STAFF RECOMMENDATION

2509 Oakland Avenue

February 17, 2021

Application: New construction—Addition

Figure 2. The two story rear addition that will be demolished.

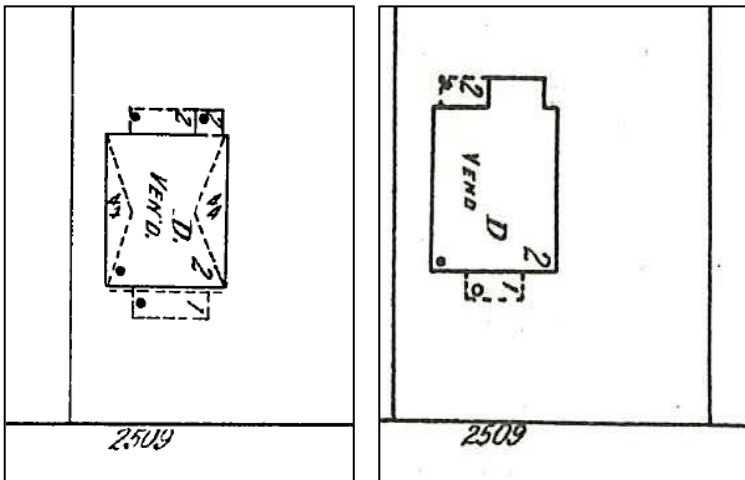
Demolition: The applicant intends to demolish a two-story rear addition (Figure 2). The rear addition may be the rear porches that appear in the 1914 and 1957 Sanborn maps that were fully enclosed after 1957 (Figures 3 & 4). Staff finds that this part of the house which is not highly visible from the street, does not contribute to the historic house’s historic and architectural integrity. Staff therefore finds that its demolition meets the design guidelines.

Staff finds that the proposed partial demolition meets Section III.B.2. of the design guidelines.

Site Layout Plan

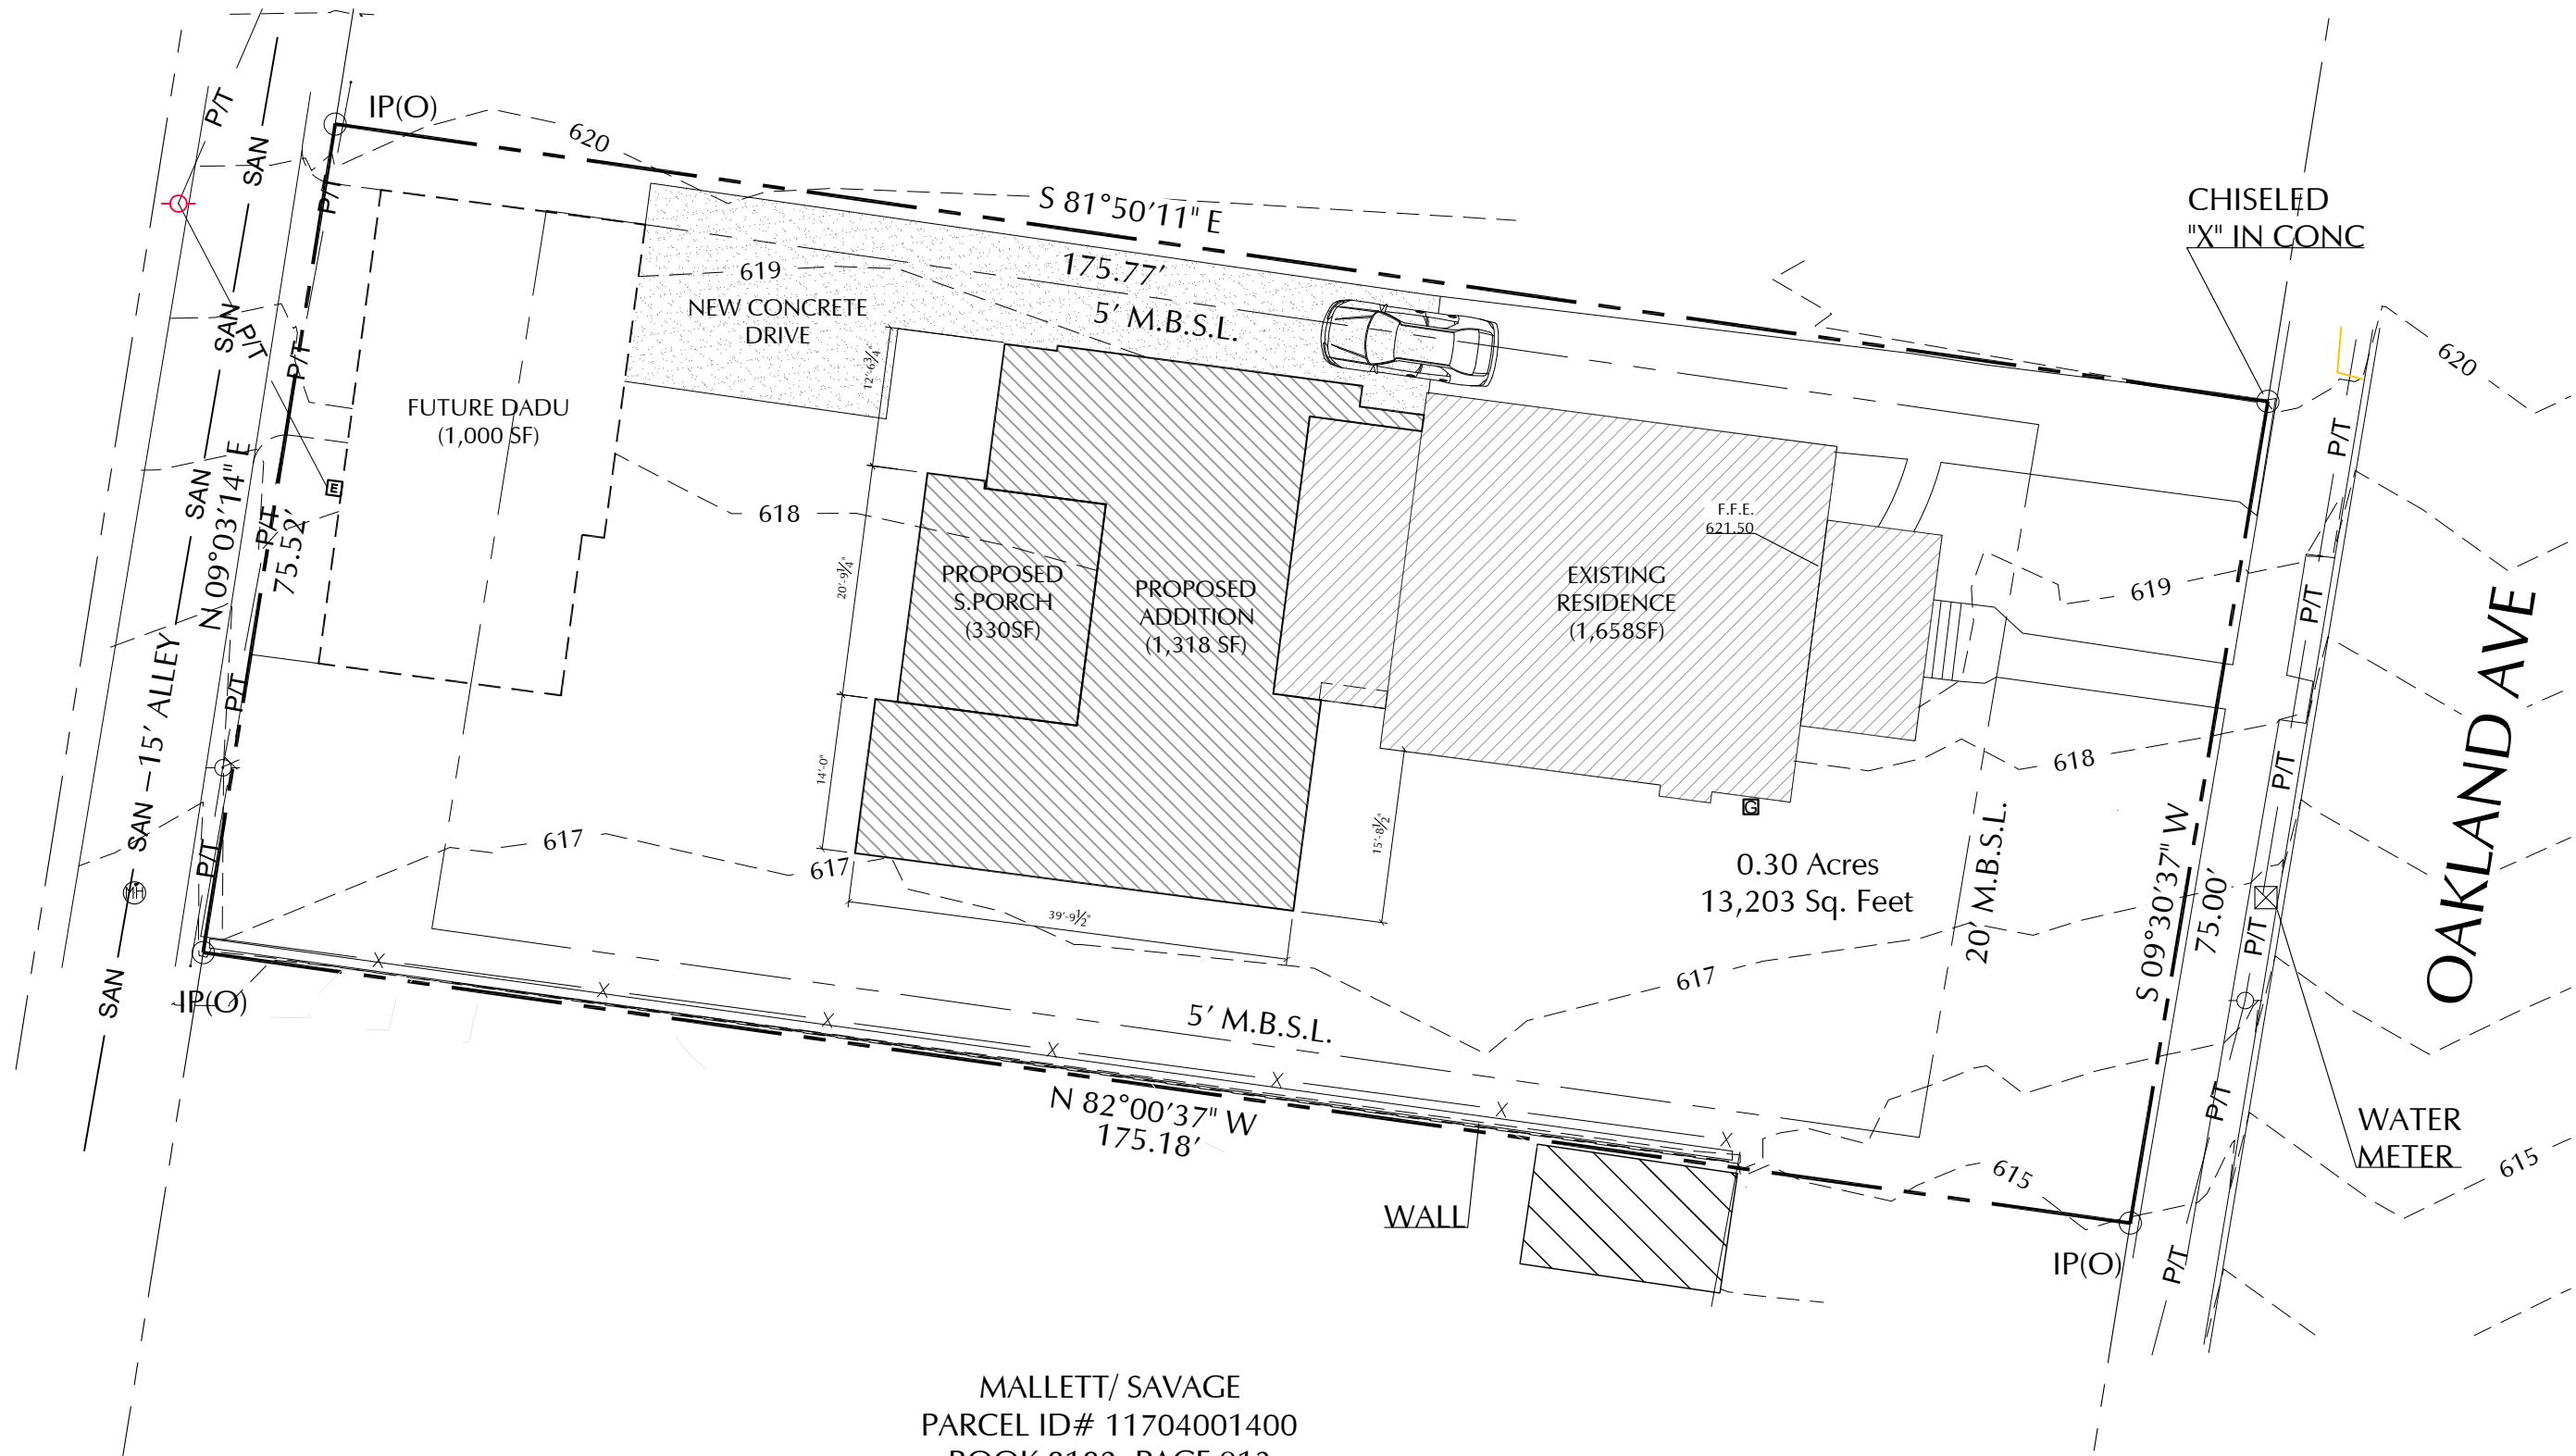
Setback & Rhythm of Spacing: The addition meets all base zoning setbacks. It is approximately ten feet (10') from the right side property line, eighteen feet (18') from the left side property line, and over fifty feet (50') from the rear property line. Even though the addition extends wider, it will not affect the rhythm of spacing along the street since it is set back significantly from the front of the house.

Staff finds that the addition's setback and rhythm of spacing to meet Sections II.B.1.c. and II.B.2. of the design guidelines.

Roof Plan

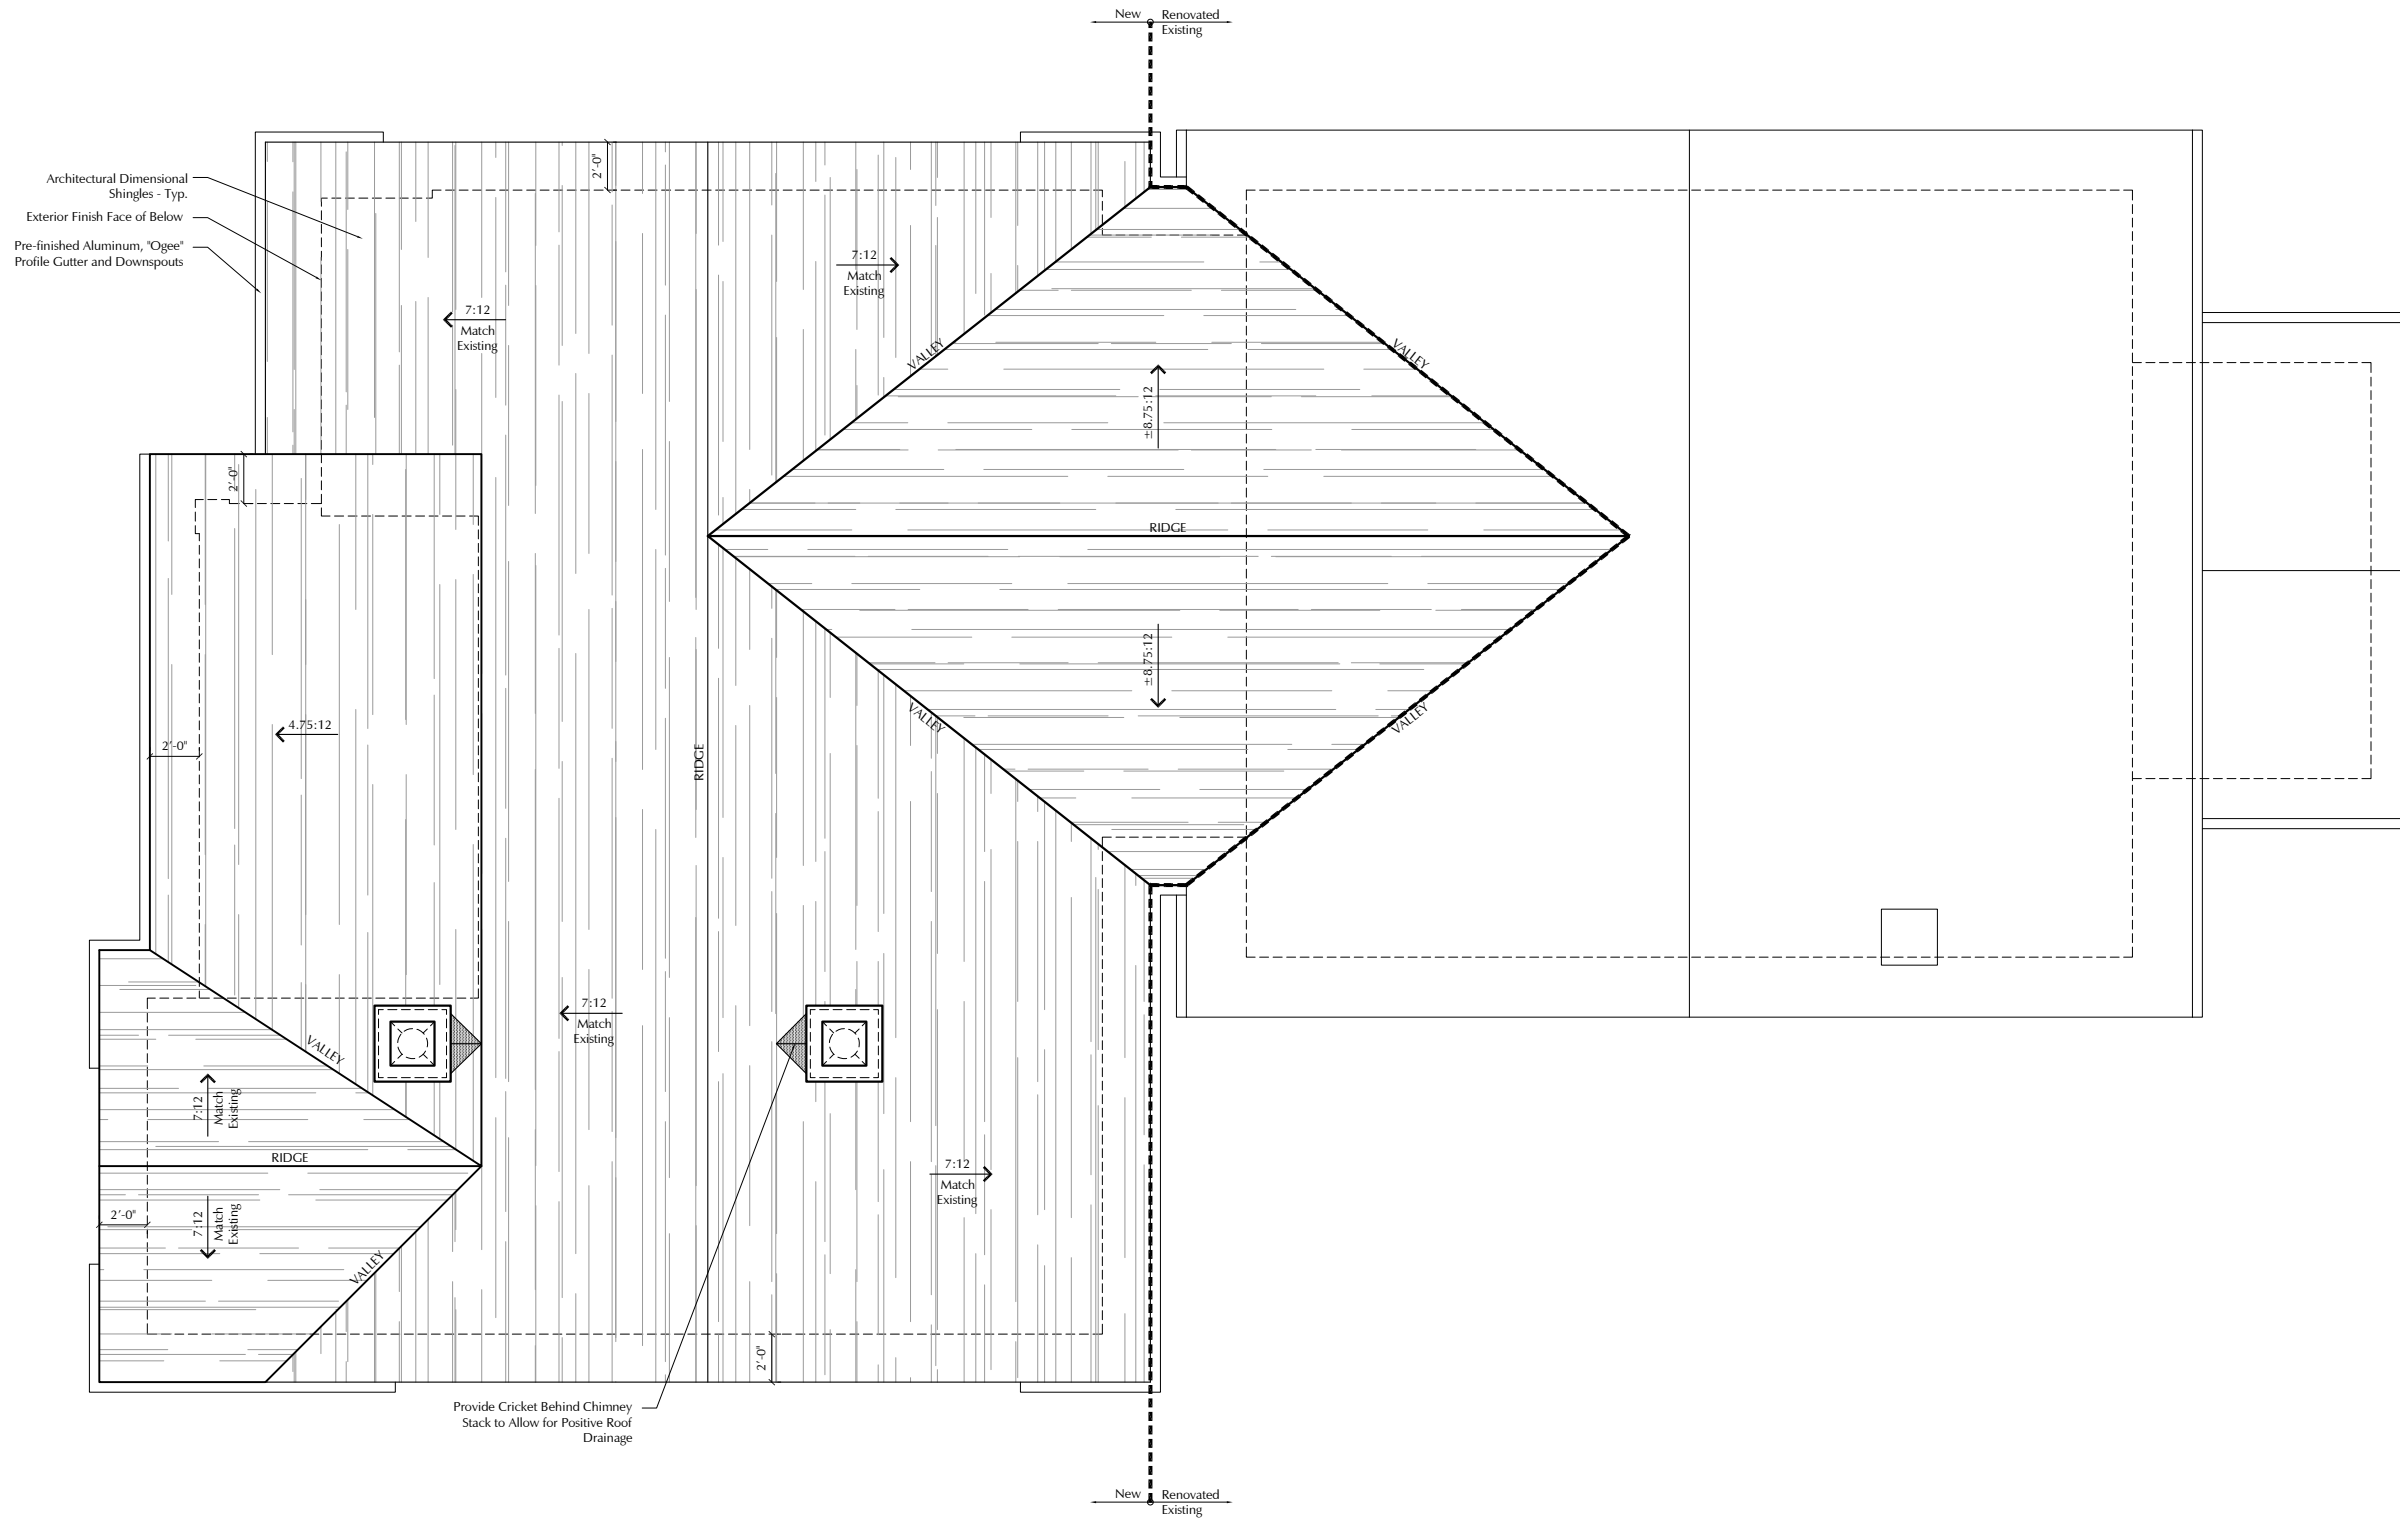
Roof form: The addition ties into the back slope of the historic house's side gable with a 8.75/12 gable that connects approximately eighteen inches (18") below the ridge. The main form of the addition is a 7/12 side gable that matches that of the historic house. No

dormers are planned. Staff finds that the proposed roof form is appropriate for this historic house and its roof form.

Staff finds that the proposed roof form meets Sections II.B.1.e. and II.B.2. of the design guidelines.
